# HISTORIC CONSERVATION BOARD AGENDA

Monday, November 7, 2016 at 3:00 pm

## APPLICATION FOR ZONING RELIEF AND CERTIFICATE OF APPROPRIATENESS HISTORIC CONSERVATION BOARD PUBLIC HEARING STAFF REPORT

APPLICATION #:  
APPLICANT: Platte Architects  
OWNER: City of Cincinnati  
ADDRESS: **1611-1613 Pleasant Street**  
PARCELS: 094-0008-0023 and 094-0008-0025  
ZONING: Residential Multi-Family (RM 1.2)  
OVERLAYS: Over the Rhine Historic District  
COMMUNITY: Over the Rhine  
REPORT DATE: October 4, 2016  
HEARING DATE: Prehearing September 14, 2016  
STAFF REVIEW: Beth Johnson, Urban Conservator

1 ELEVATION EAST/FRONT  
A1.01 SCALE: 1/8" = 1'-0"

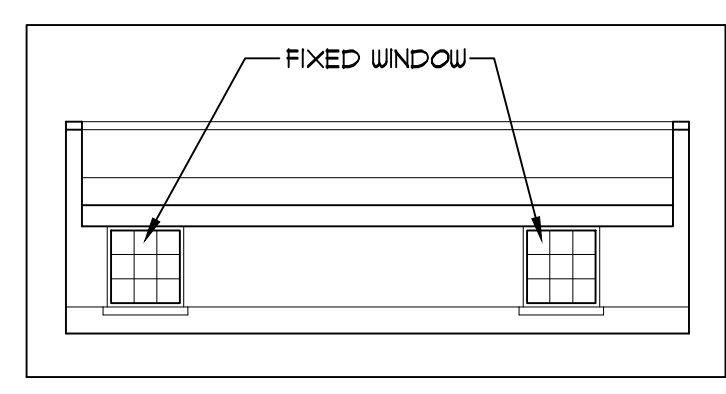
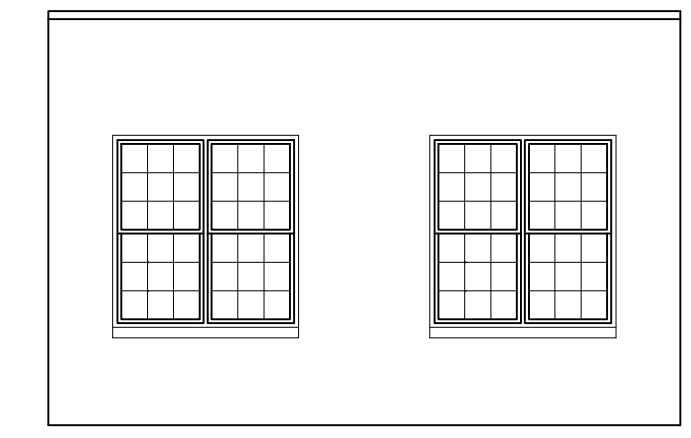
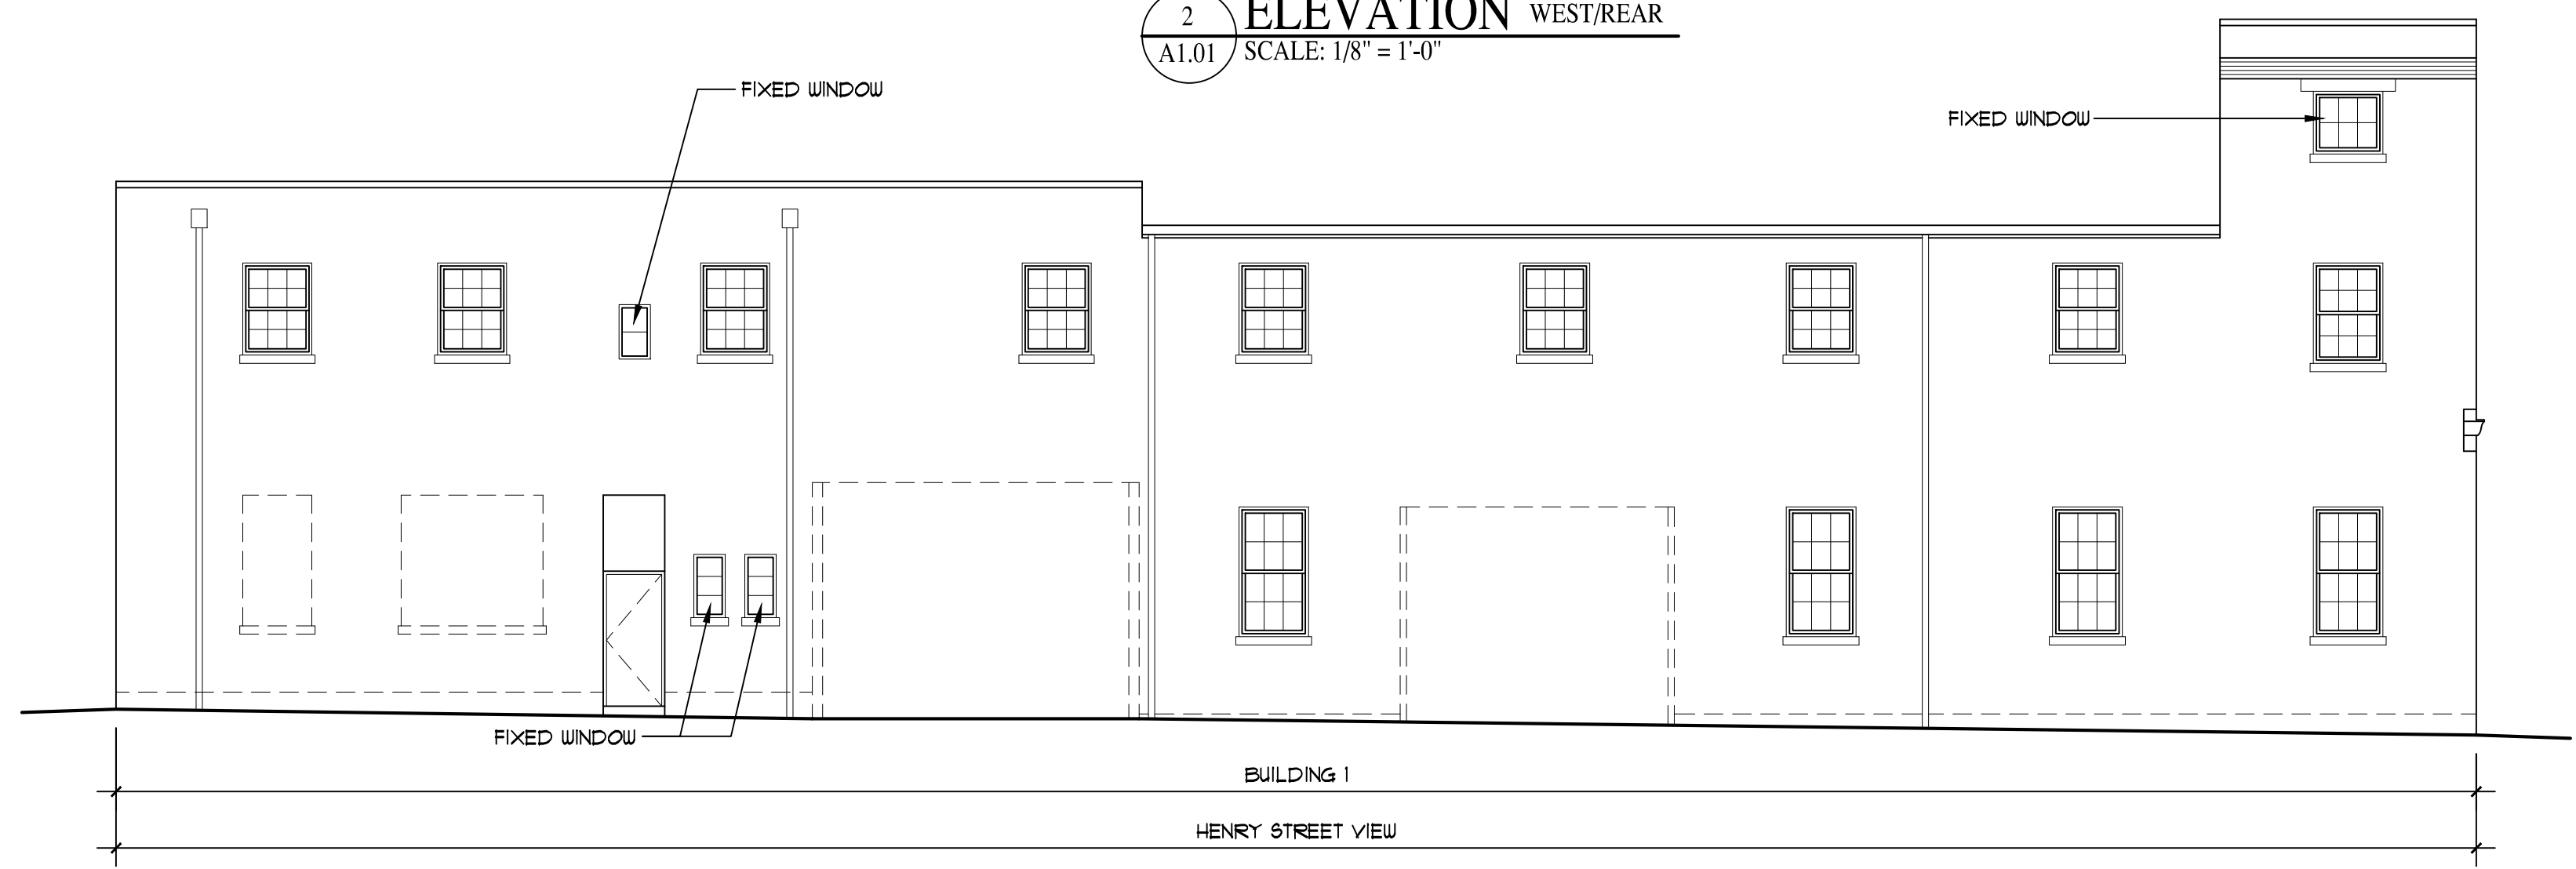
- A. **Deny** a Certificate of Appropriateness for 2007 Dunlap Street for windows with internal/integrated mullions as specified on plans submitted by Casler Design Group and dated 8-29-2016.
